V-18-002
U-17-077
S-17-042

November 14, 2017

RE: 400 - 402 Blossom Hill Road

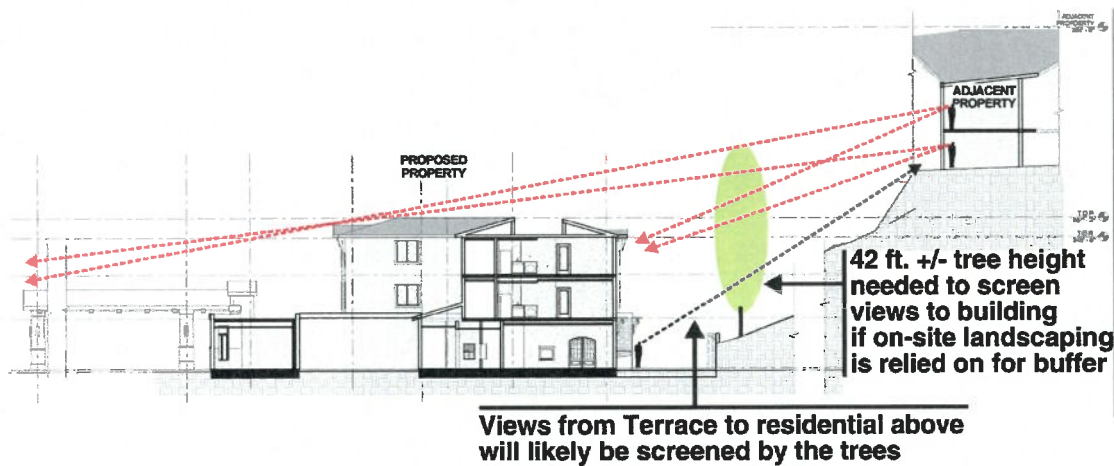
1. The construction of the new building would necessitate the removal of several large trees along the eastern boundary of the site - see illustration below.

I am unable to evaluate whether the remaining trees on the adjacent slope would be adequate to screen views to the new three-story building from the multifamily homes above. It appears that some limited new planting of California Buckeye trees is proposed along the eastern edge of the property, but it looks like three of the four trees are located outside of the site boundary. California Buckeyes have the potential to grow up to 20-40 feet in height, but I don't know how long that might take and whether the sloped hillside environment would be conducive to reaching their maximum height potential. If the existing trees on the adjacent parcel to the east are insufficient to screen views to the new building, trees on the project site would likely need to be in the 40-foot range to provide screening of the roof and mechanical equipment well of the new structure- see illustration below.

An additional caution would be to explore with the applicant's design team whether the roof-mounted mechanical equipment would have the potential for noise intrusion on the residential units above the site.

Recommendation: Explore these issues and potential mitigation measures with the applicant.

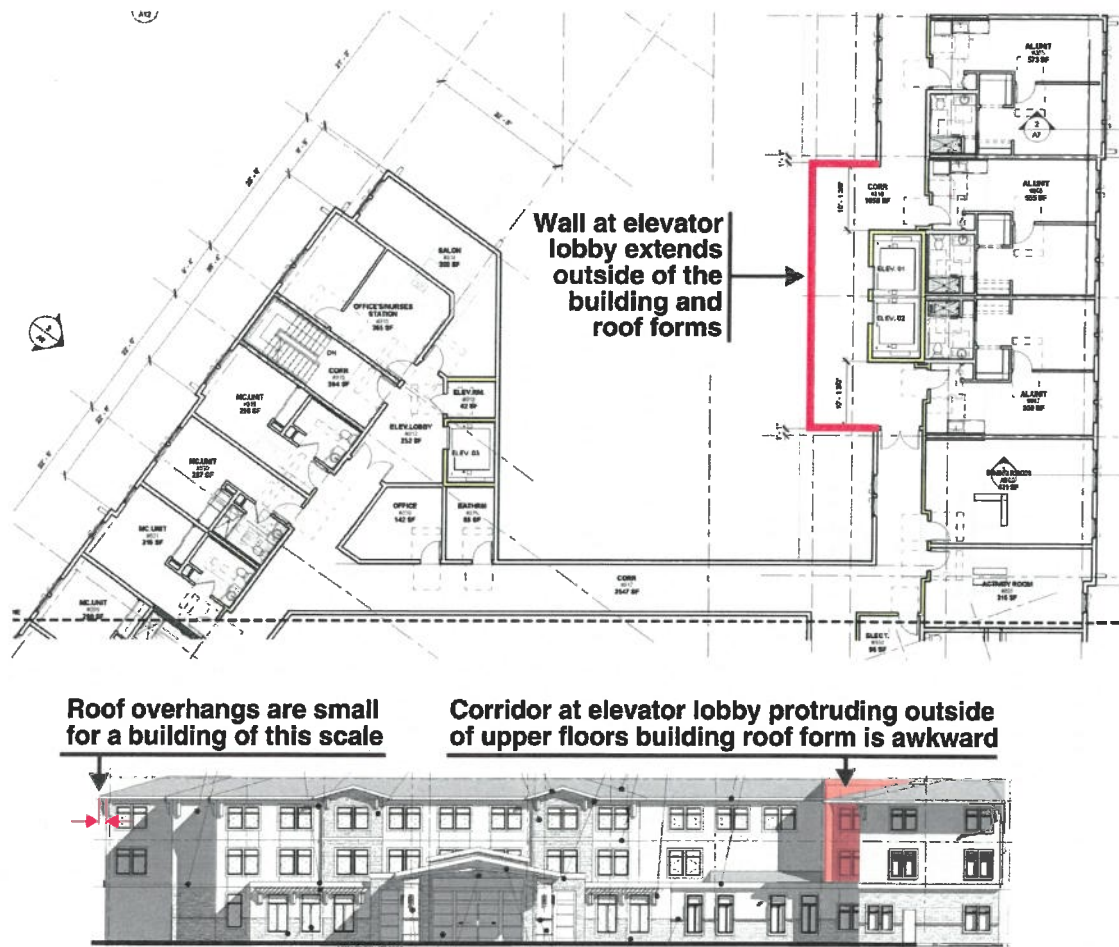
3. The depth of the bay elements faced with stone is quite small for a building of this scale.

Recommendation: Substantially increase the depth of all of the bay pop outs.

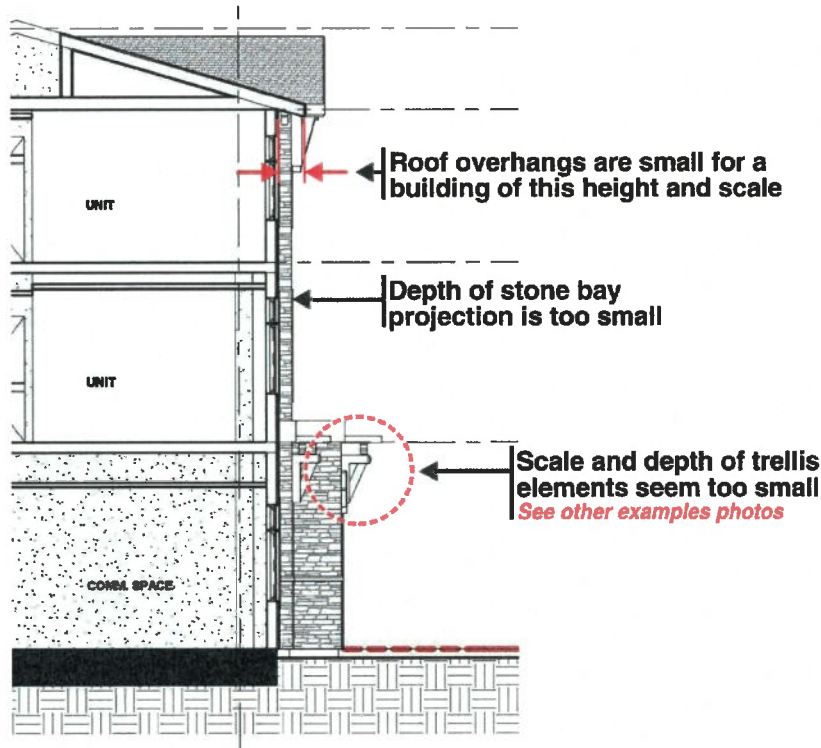
5. The location of the elevators necessitates a jog in the corridor on the upper levels which pushes a stucco box outside the building and roof forms. This condition is not consistent with the overall design of the building. The condition is created by the shallower building depth on upper floors from the east wall to the corridor than is provided on the first floor. Therefore, the corridors are not aligned vertically.

Recommendation: Revise the floor plans to keep the corridor within the overall building and roof forms. Alternatively, explore design alternatives to better integrate the corridor pop out into the character and design of the building.

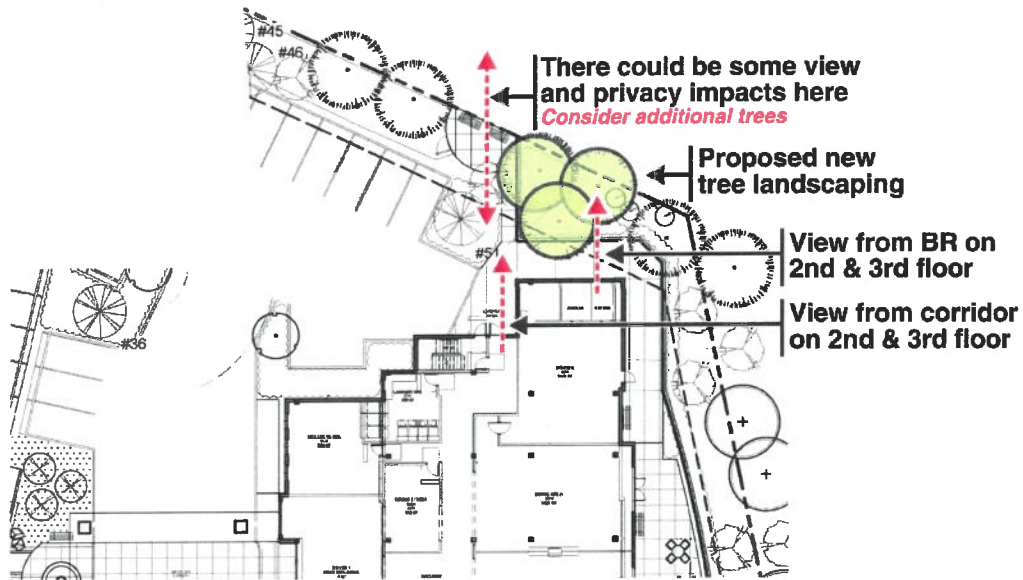
You specifically asked about the relationship of the new building to the two-story building on the adjacent property. The potential issues are views to the new three-story building and privacy intrusion views into the existing multifamily units windows and private open space. There is one set of bedroom windows and one single corridor window on the north facade at the second and third floors of the new building - see diagram on the next page.

The landscape plan shows new trees at the north property line. The drawing key is not altogether clear, but it appears that there will be California Redwoods planted at the north end of the building. That should shield views to and from the new building at the bedroom windows. There appears, however, to be a gap in landscaping in the areas of the new outdoor seating area.

Recommendation: Consider adding additional trees.
